**Submission to the
NSW Department of Planning and Environment
KEPCO - Bylong Coal Project**

November 2015

Bylong Valley Protection Alliance Inc

Figure 4.1B: Connective fracturing reaching the surface (from Appendix M)

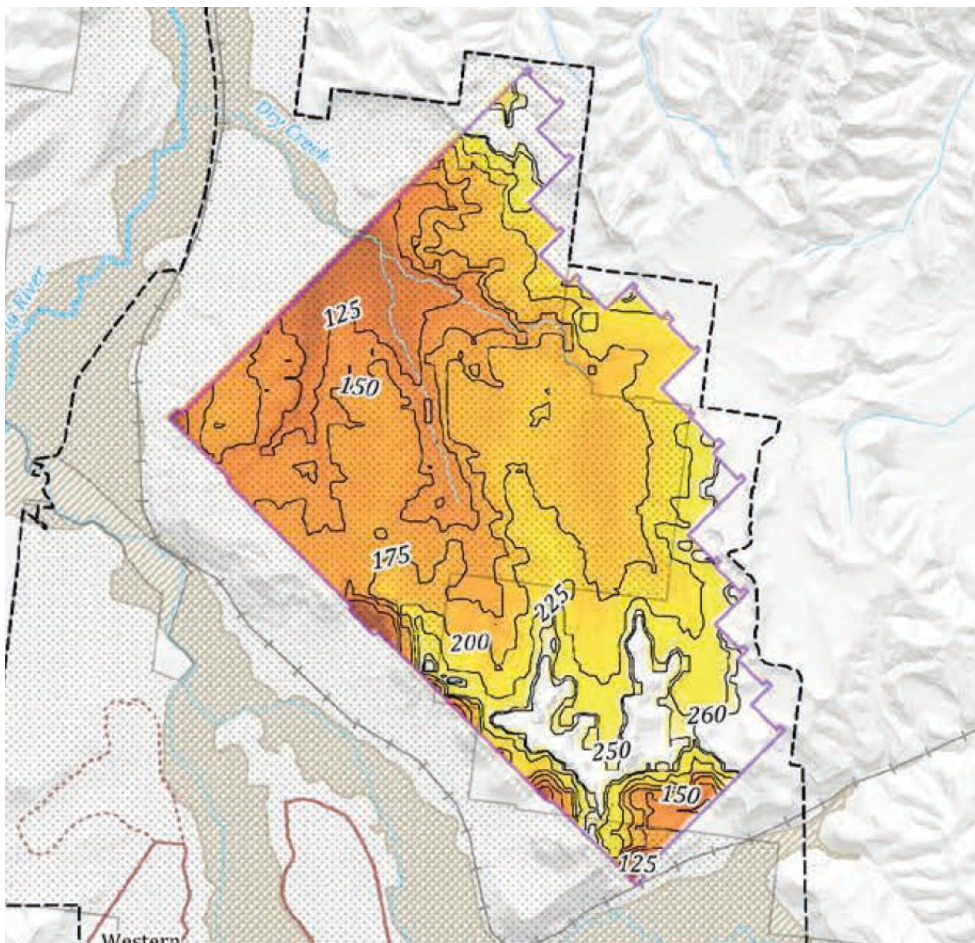
Figure 4.1B shows that mine subsidence is expected to cause connective cracking through to the surface within much of the catchment area of Dry Creek.

Figure 4.2: Location of Dry Creek

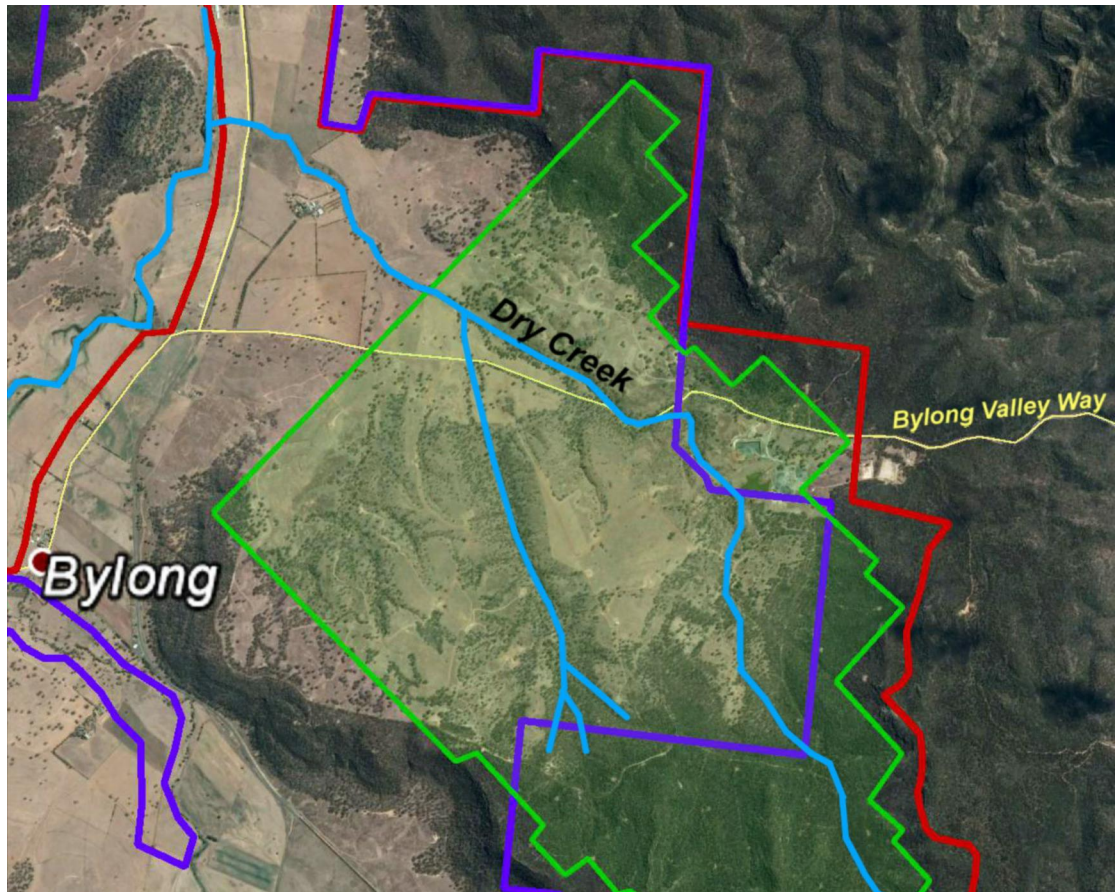
The longwall mining will extend under Dry Creek (see Figure 4.2). The predicted impacts stated in the EIS include the following:

While the name may be convenient as indicating a creek of little value, the truth is that Dry Creek is an ephemeral stream, of 3rd order in its lower reaches, with a catchment of about 14 sq km.

Figure 4.3: Cliffs C1, C3 and C4 (there are 41 cliffs >10m high; >20m in plan length)

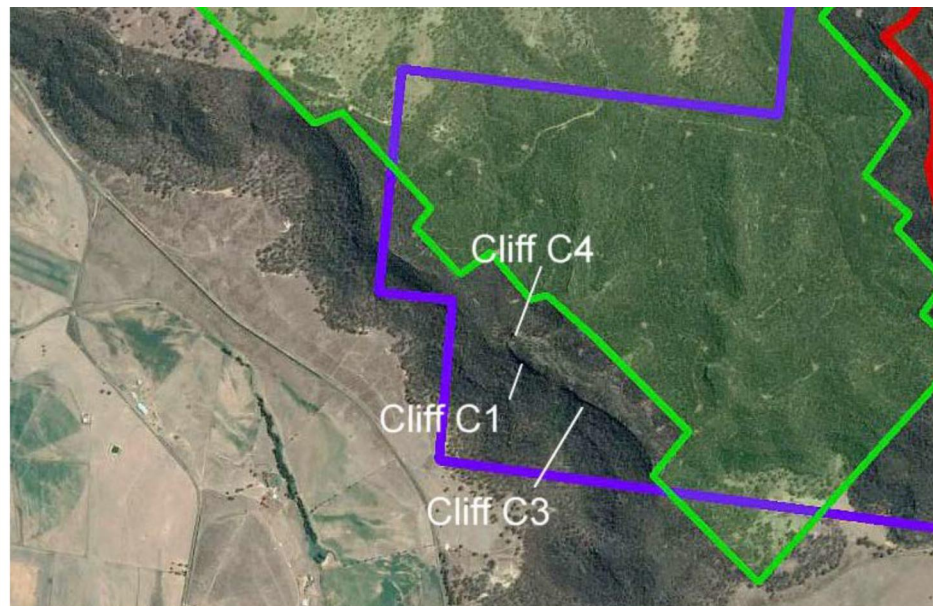
The EIS predicts that subsidence will cause collapse of parts of the cliff lines above the area of longwall extraction (see Figures 4.3, 4.4A and 4.4B). It is stated (p139 of main text) that the mine plan was altered to “minimise significant impact” (whatever this may mean quantitatively) to protect Cliffs C1, C3 and C4, shown in Figure 4.3.

The layout of the longwalls makes it less likely that there will be collapses on the southern side of the cliff line shown in Figure 4.3, where such damage would be clearly visible from the vicinity of Bylong. The damage predicted in the EIS, as discussed below, will be concentrated on the northern side of the ridge line, and far less visible to the public.

Figure 4.8: Computed net changes in river flows

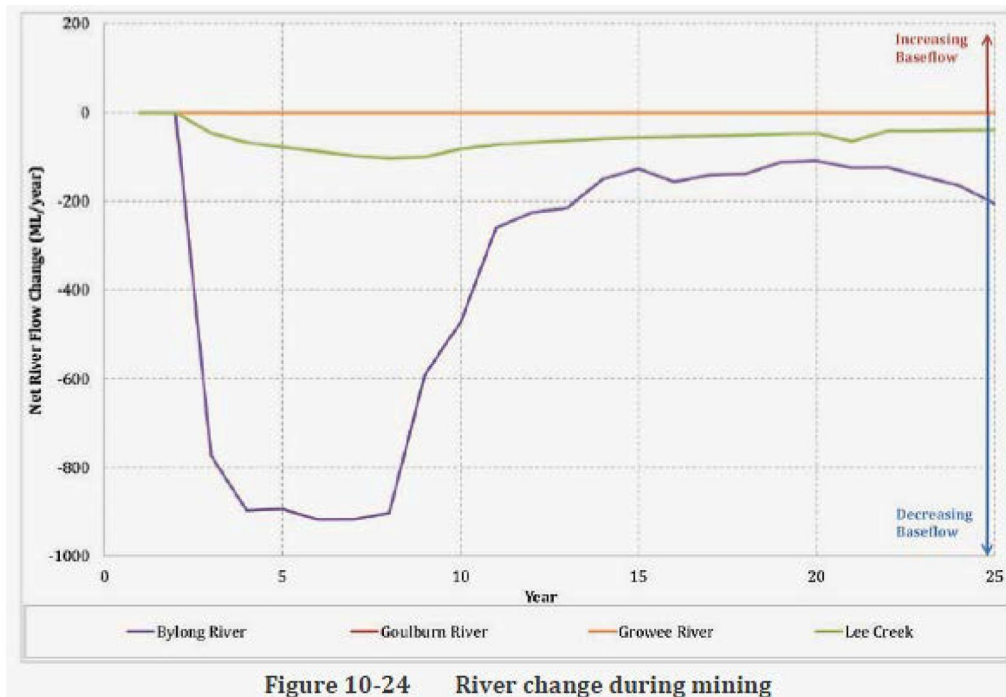
Points 1 and 3 in Box 1., and impacts to Dry Creek, relate to streamflow's in creeks. Clearly, the quantities of water planned to be drawn from the alluvial aquifer, and changes to the watershed shape and character, have the potential to impact on streamflow significantly (see Figure 4.8).

As shown by Figure 4.9, the 'net' flow change is significant, but this figure gives no quantification of the impacts on flow frequency. Impacts to streamflow is considered in the EIS in terms of "water availability" – and the impacts therefore appear to be addressed by management of water licencing.

Figure 4.9: Conceptual hydrogeological model from the EIS

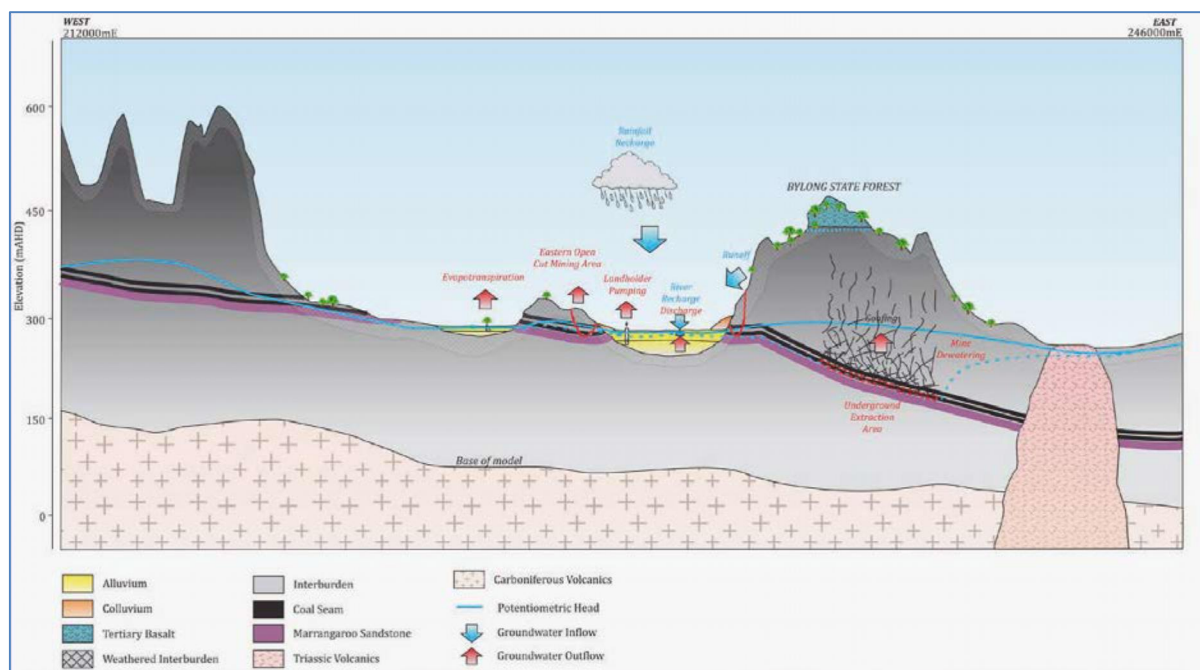
The hydrogeological conceptual model is shown in Figure 4.9.

We have been unable to find, within the main text of the EIS, or Appendices H (Subsidence), L (Surface Water) and M (Groundwater), a reasonable representation of the stratigraphic profile above the longwall panels. Appendix H provides the following 'cartoon' stratigraphic column (see Figure 4.10) – but it does not allow understanding of the distribution on the Triassic strata above the longwall panels.

Figure 4.12: Tertiary basalt capping

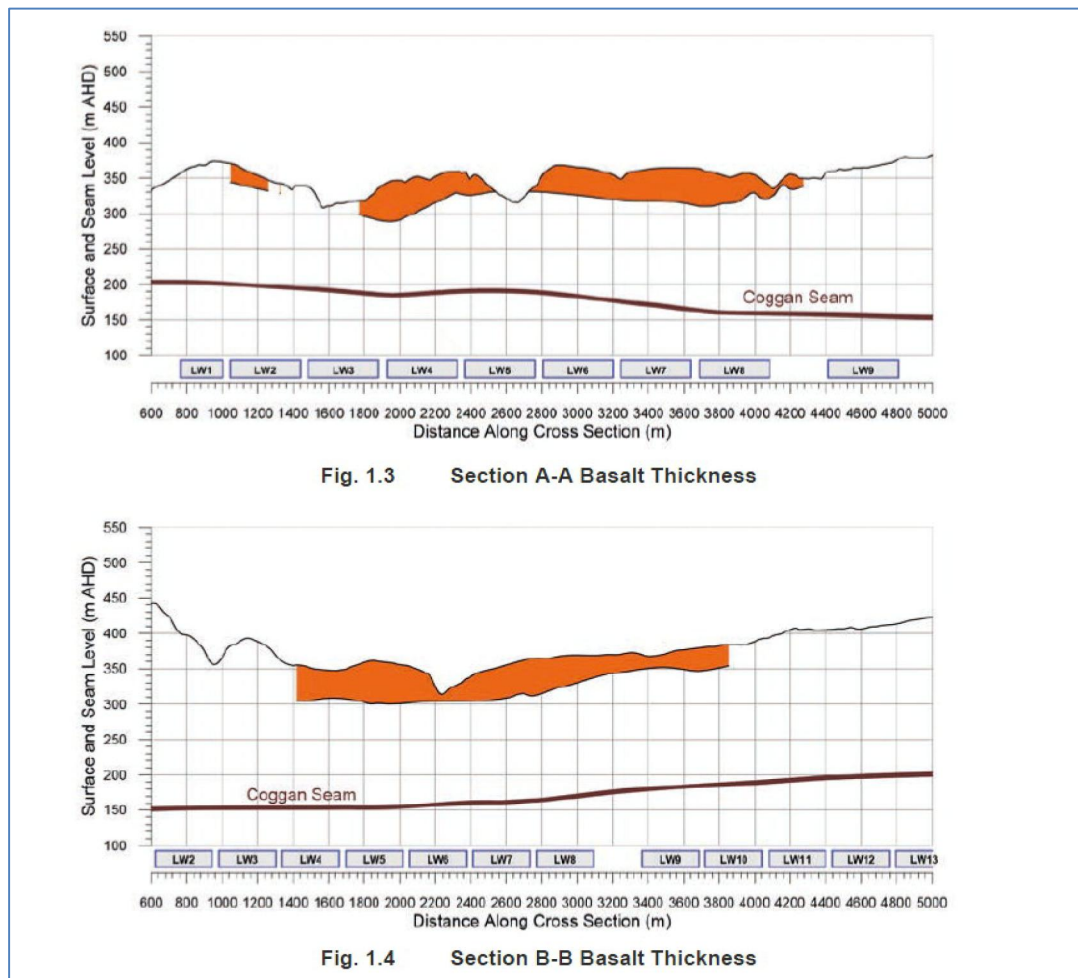
This is also consistent with the following cross-sections from Appendix H (Figure 4.12) which show the Tertiary Basalts.

Elevated groundwater levels in the Tertiary basalt region are interpreted in the EIS to be “perched” due to increased recharge through the basalt. This elevated water level may be the case, but the inference of this groundwater as being “disconnected” from the rest of the geological sequence, as is stated in the Main text of the EIS, is without basis. Rather, the elevated level indicates increased vertical potential for movement vertically through the whole sequence.

Figure 4.13: Sensitivity analyses given in Appendix H

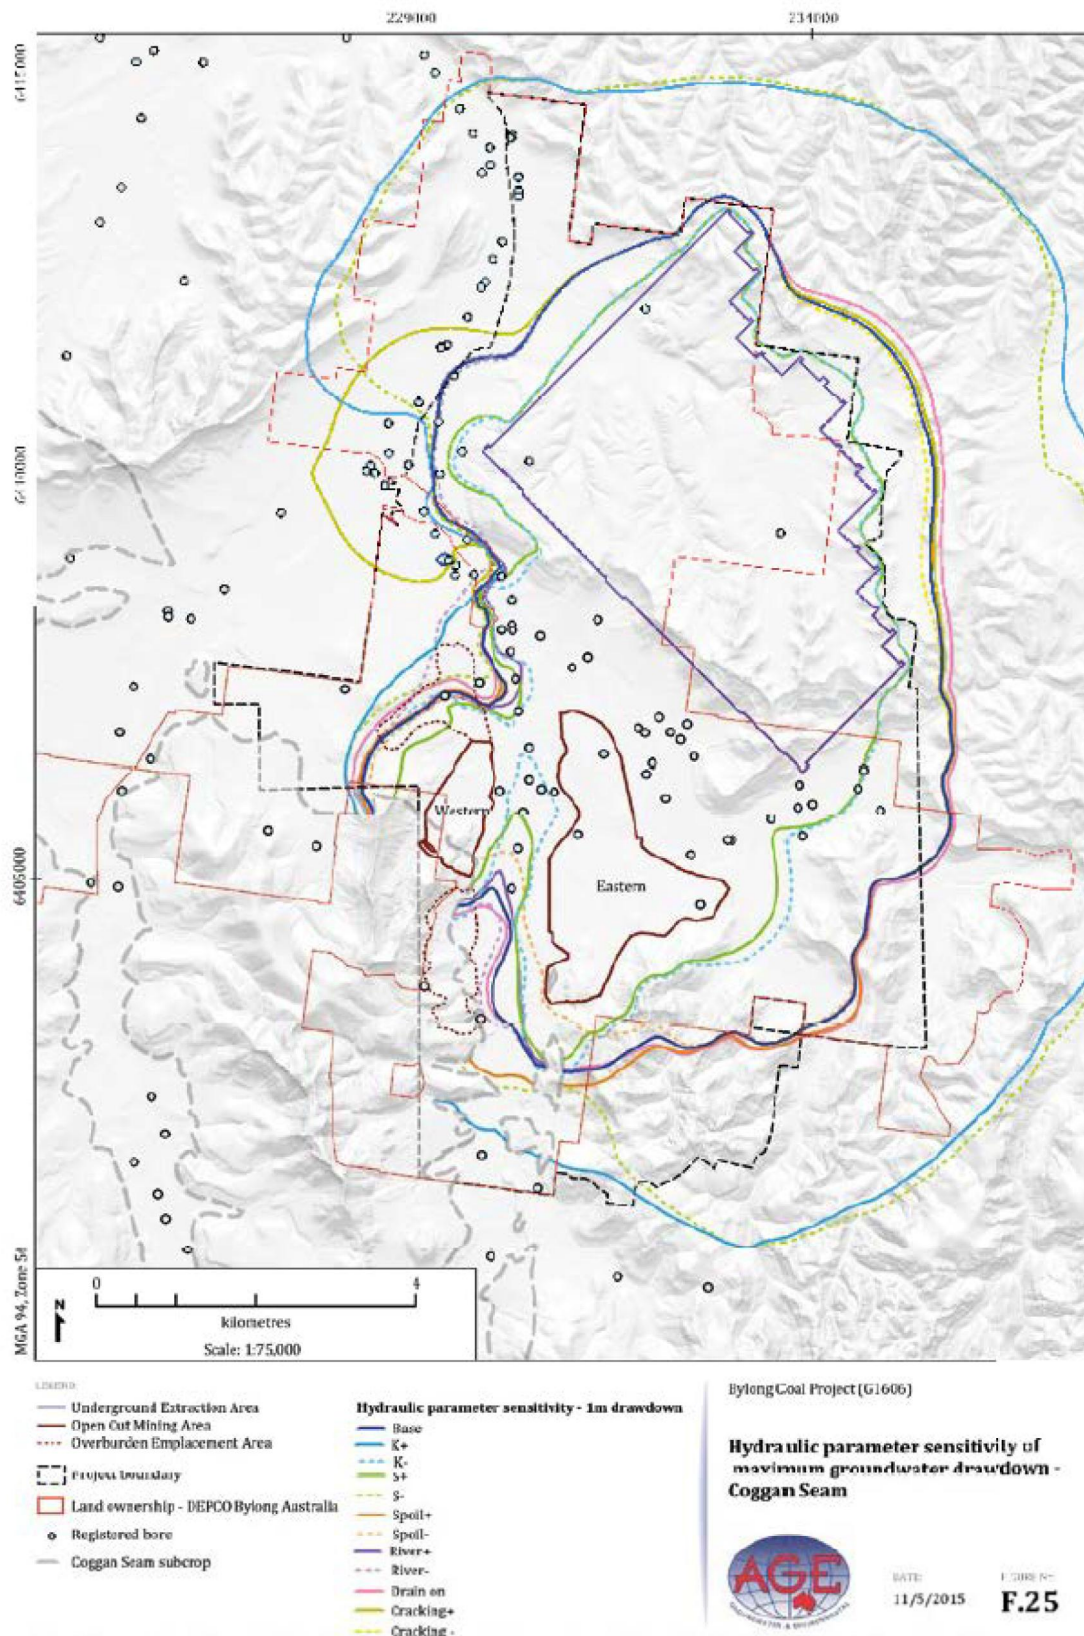
Technical sensitivity analyses of the modelling parameters were undertaken in the EIS, presented in Appendix F to the Groundwater Impact Assessment. In Figure 4.13, the effects of sensitivity of some hydraulic parameters in the predicted extents of drawdown are shown. It is clear from our calculations presented above that much larger drawdown extents will be incurred with more appropriate diffusivity values.

We note also that groundwater impacts (and drawdown mapping) asserted within the main text of the EIS are declared on a single model output alone. This is inappropriate, and does not adequately communicate the uncertainty in predicted impacts.

The model should be recalibrated using physically possible diffusivity values, and model results, and drawdown extents should be re-produced based on these revised models.

Figure 4.15: Annual bore-field water requirements

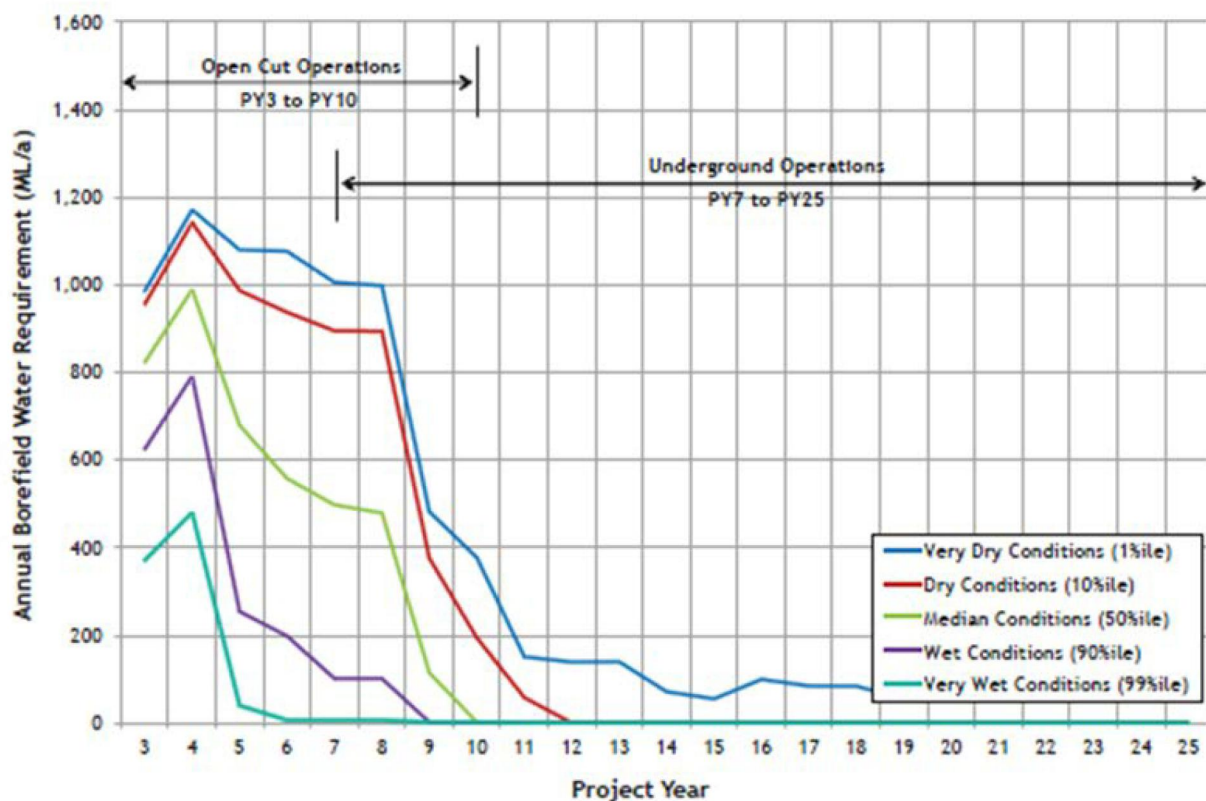
The information given in the EIS in respect to yield testing of the alluvium in the area of the proposed borefield (see Figure 4.16) indicates to us that very low confidence can be placed on the validity of the results given in Figure 4.15.

A substantial pumping test program would be necessary to demonstrate that the borefield can in fact provide the critically required water for the 1st decade of the mine life.

Figure 4.17: Predicted drawdown at the level of the Coggan Seam

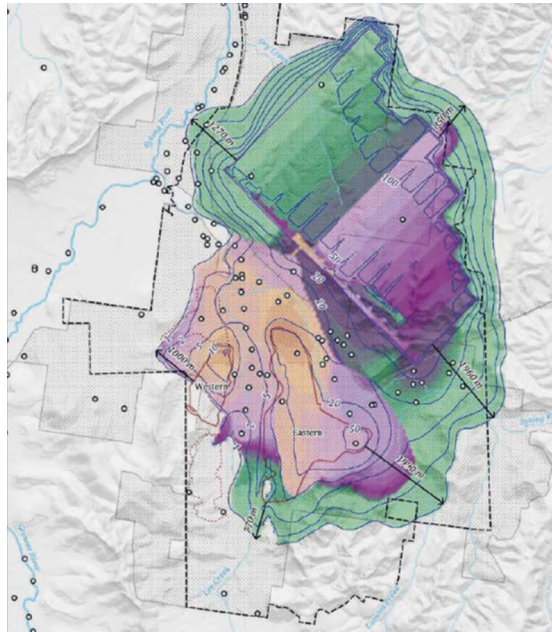
The predicted depressurisation at seam level is shown in Figure 4.17. The extents are predicted from the modelling supplied in the EIS to be largely contained within the lease boundary.

However, this extent is subject to the aquifer parameters adopted. As stated in Question 6, presentation of drawdown extents from alternative scenarios that use more realistic values of hydraulic diffusivity are essential, and are likely to shown greater drawdown extents.

We note that Figure 4.17 is for drawdown at the level of the mined seam. As discussed in Section 4.4, we have been unable to find within the EIS a proper analysis of the depressurisation of the rock strata above the Coggan Seam. The one piece of information we can glean is from the cross-sections reproduced in Figure 4.18.

Figure 4.18 Computed pre-mining and post-mining groundwater regimes.

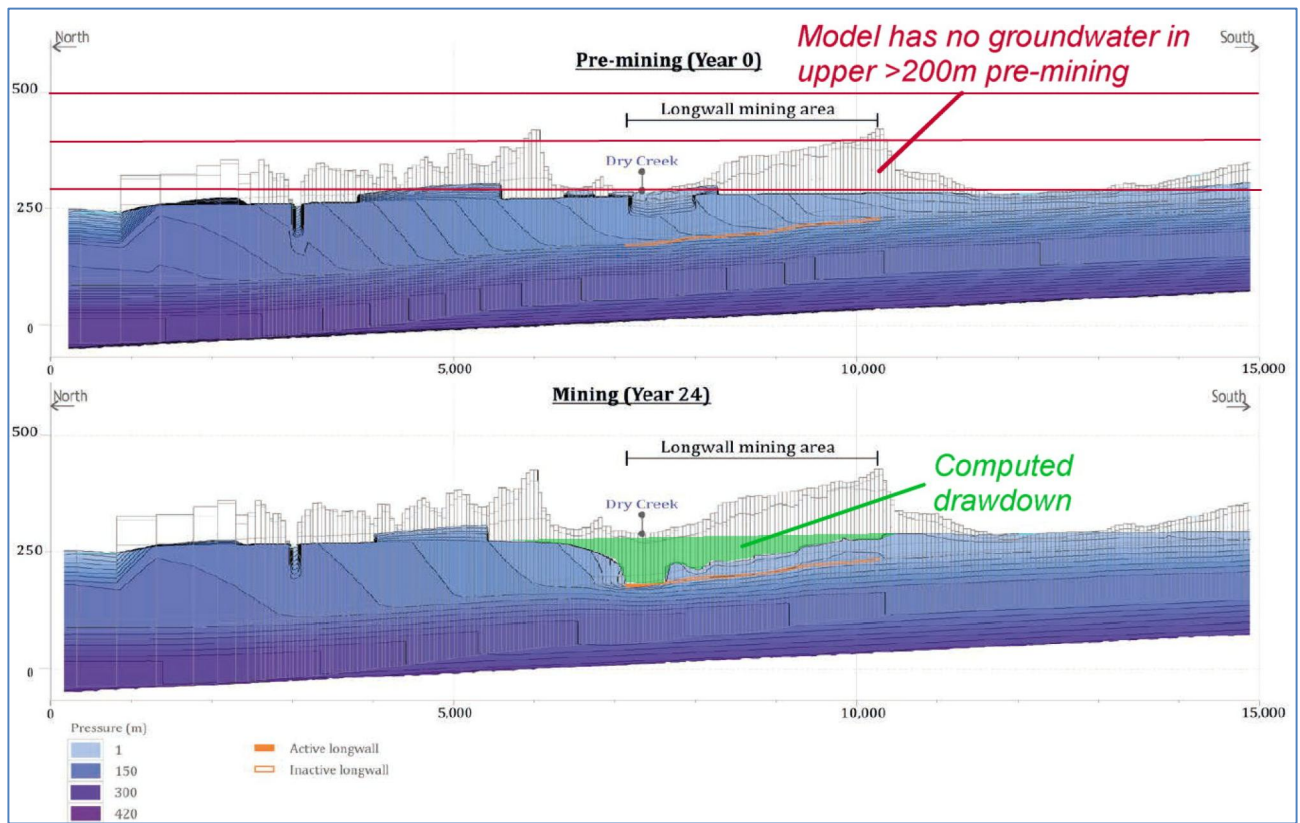
These cross-sections show no groundwater within upper >200m of strata in the profile prior to mining. Based on our experience at other collieries in the NSW mountain areas (Clarence, Baal Bone, Springvale, Lithgow Valley) we cannot accept this assumption without justification from sufficient field measurements.

We think that when the model is re-run with appropriate rock mass stiffness values, and proper representation of the Triassic strata, it will be found that depressurisation impacts will extend well beyond the Proponents property boundaries. However, as discussed in Section 2 of this report we think that that it is illogical for unacceptable environmental impacts within the Proponents property to make those impacts acceptable to society.
